Groundwater Application Review Summary Form

Application # G- 18723

PUBLIC INTEREST REVIEW FOR GROUNDWATER APPLICATIONS

TO: Water Rights Section Date 11/20/2018
 FROM: Groundwater Section Aurora C Bouchier
 Reviewer's Name
 SUBJECT: Application G- 18723 Supersedes review of na
 Date of Review(s)

Water-Level Trends in Nearby Wells

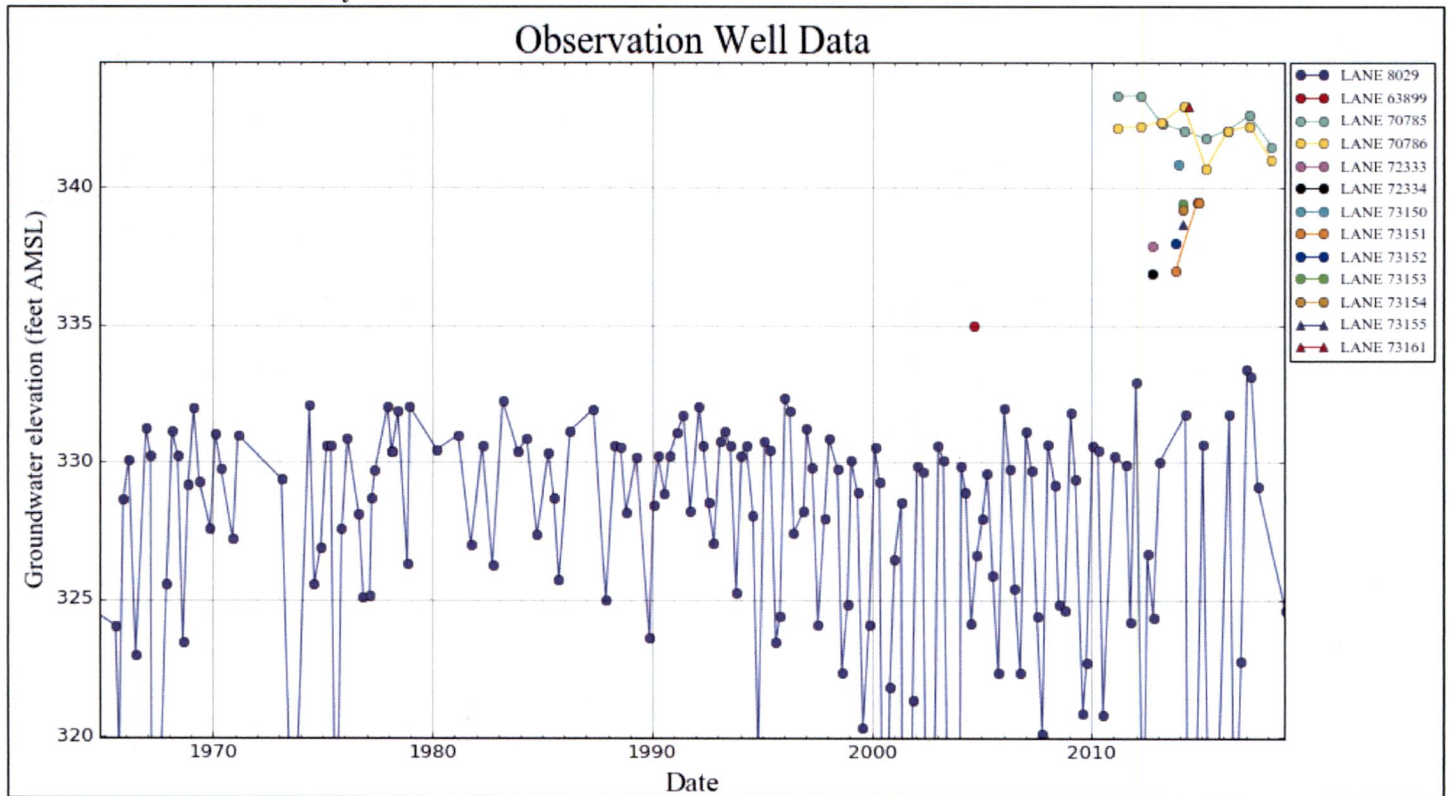
Nearby long-term observation well, LANE 8029 (located approximately 1.6-miles to the northeast) shows a stable, long-term water-level trend since the 1960's. LANE 8029 is completed such that it likely produces from both confined- and unconfined-components of the aquifer system. Nearby permit G-16402 (app G-17069) authorizes production from two wells producing from the confined component of the aquifer system: LANE 70785 and LANE 70786. The water-level trend for these two wells shows a water-level decline of approximately 1- to 2-feet between 2011 and 2018, which may indicate that the confined aquifer outside of the river floodplain may not be as stable as within the floodplain. This speaks to the need for annual water-level measurements for new permits which may be issued in this area.

The hydrograph below includes water levels for 11 nearby wells with completion depths greater than 100-feet, LANE 8029 (described above), and LANE 63899, a shallow domestic well located approximately 490-feet from the proposed well location.

The proposed well is just west of the DEQ Southern Willamette Valley Groundwater Management Area which was established in response to widespread contamination of the shallow, unconfined aquifer in the southern Willamette Valley. **To preclude cross-contamination between the unconfined and the confined aquifers system, the proposed well should be continuously cased and continuously sealed to a depth of 100-feet so that production is restricted to the confined aquifer system.**
